IN RE APPLICATION: Toyotaka HIRAO, et al.

SERIAL NO.: 10/644,728

FOR: VEHICULAR AIR CONDITIONER

LETTER SUBMITTING REPLACEMENT DRAWING SHEET(S)

FIG.3

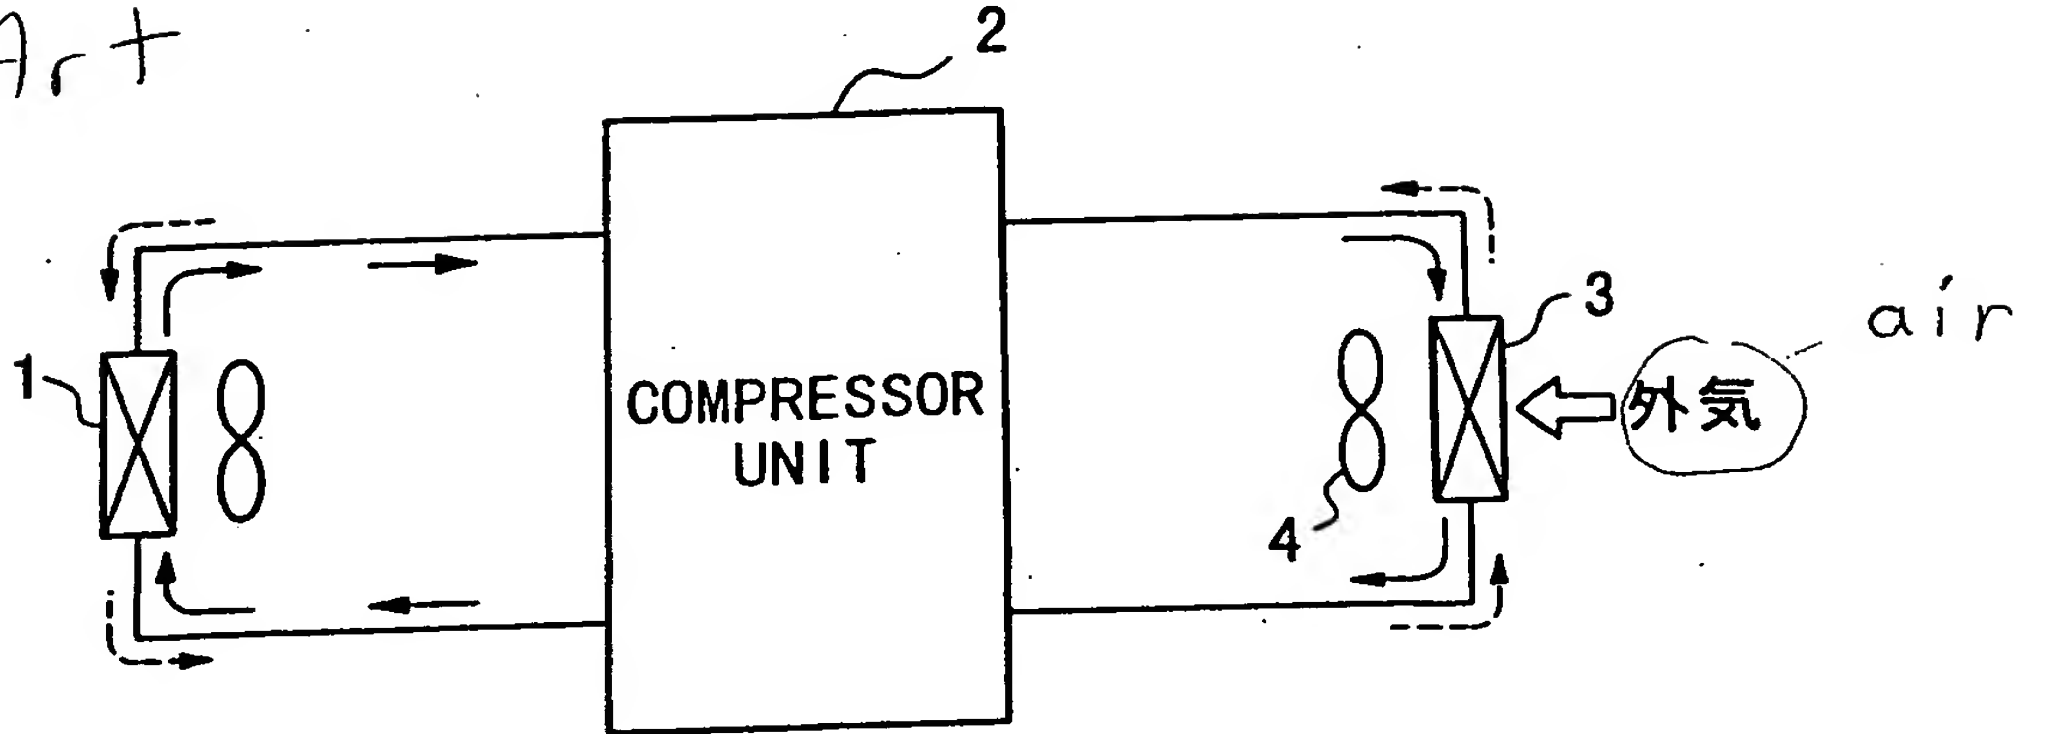
As stated above the drawings are objected to. In response, as shown in the attached replacement sheet, Figures 3 and 4 are amended to be labeled "Background Art," and Figure 3 is amended to include the term "air" in place of Japanese characters, in accordance with the Examiner's request. Although not required under 37 C.F.R. § 1.121(d), enclosed for the Examiner's convenience is a marked-up copy of Figures 3 and 4 submitted in accordance with 37 C.F.R. § 1.121(d)(1). It is requested that the objection to the drawings be withdrawn.

The replacement Figs. 3 and 4 include changes required by the PTO Communication. A marke-up version is also included per request of the Examiner.

Background Art
